PR#: PR-51
FRN#: 78FR56775
NRC DOCKET#: NRC-2012-0246
SECY DOCKET DATE: 11/19/13
TITLE: Waste Confidence—Continued Storage of Spent Nuclear Fuel
COMMENT#: 00211

RE: Docket No. NRC-2012-0246
Environmental Impact Statement for Waste Confidence Rule
10 CFR §51.23

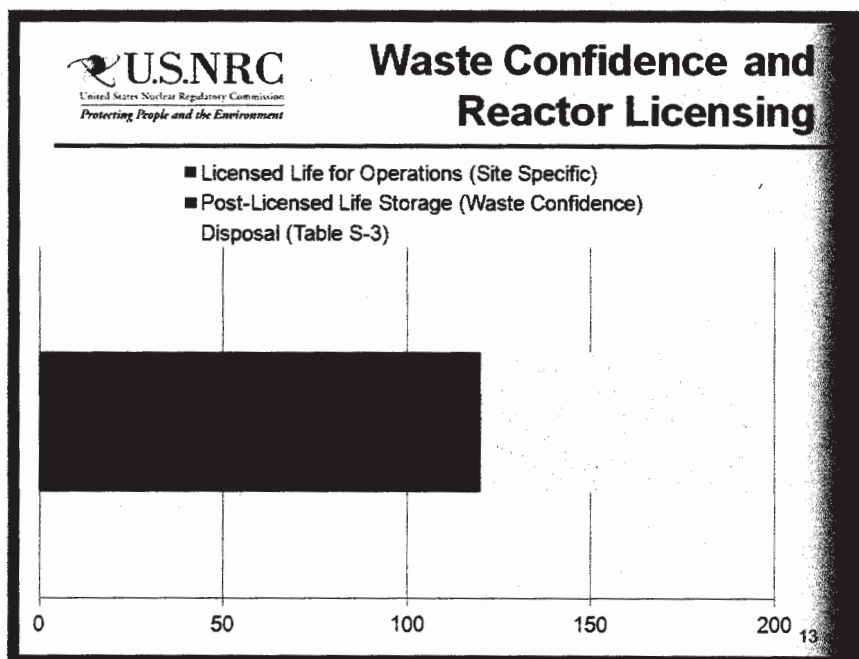
Scenario Three is "unavailability of a national nuclear waste repository." The scenario of a repository being unavailable is the most likely of the three and the yellow arrow in slide number 13 should extend for at least 10,000 years and have 65 arrow points.
